X3T9.2/88-98

August 5, 1988

TELL US ABOUT YOUR SCSI APPLICATIONS

MANIP1 EM4-REC2

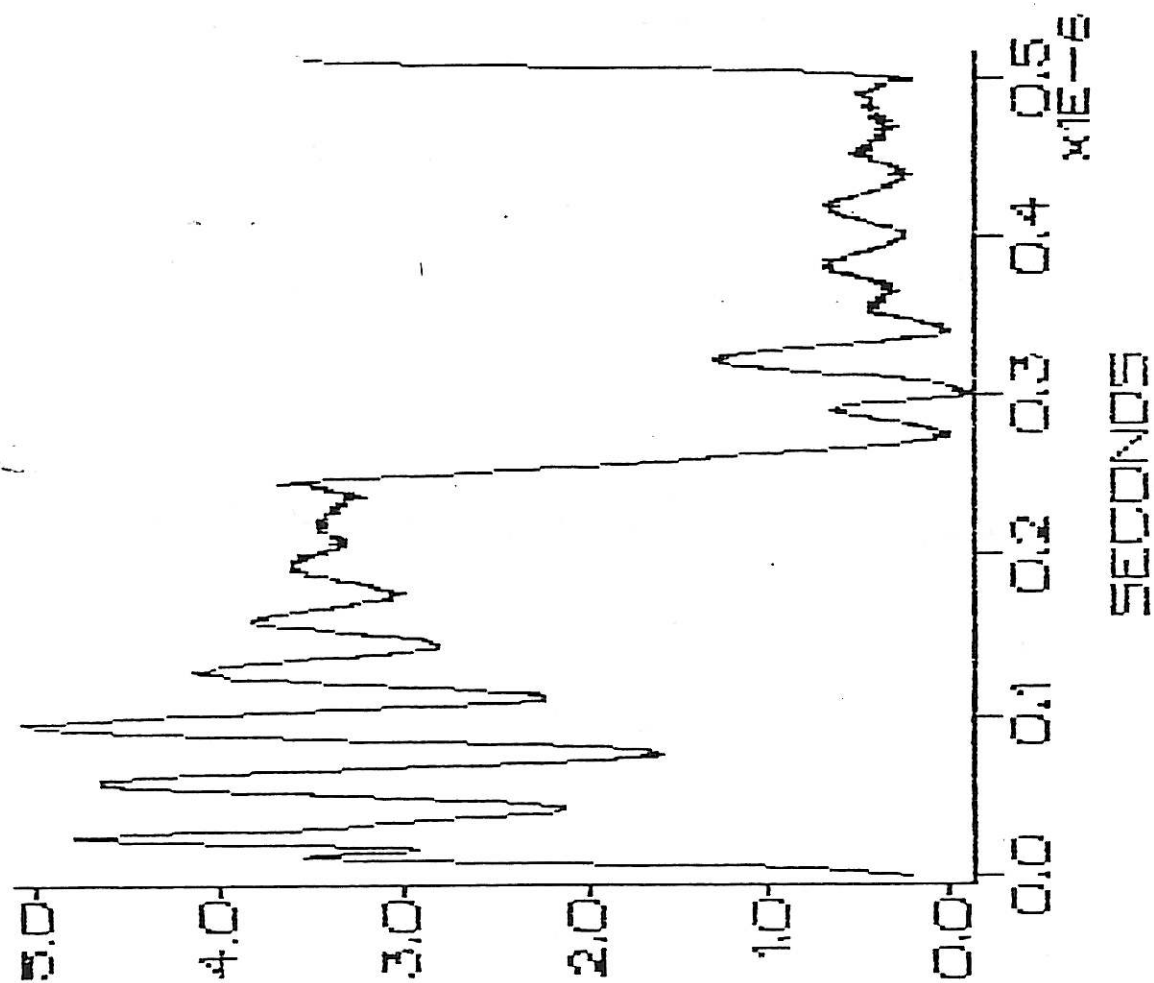
When using recommended electrical SCS,
standard of the single-ended alternative,

we have ringing signals meaning that the

SCSI BUS IS NOT WELL TERMINATED.

For example 8 devices (target or initiator)
equally placed on a 3 meter cable (with $100\ \Omega$
characteristic impedance).

Please find some bad copies of some signals
observed with an oscilloscope on a SCSI bus
with this configuration.
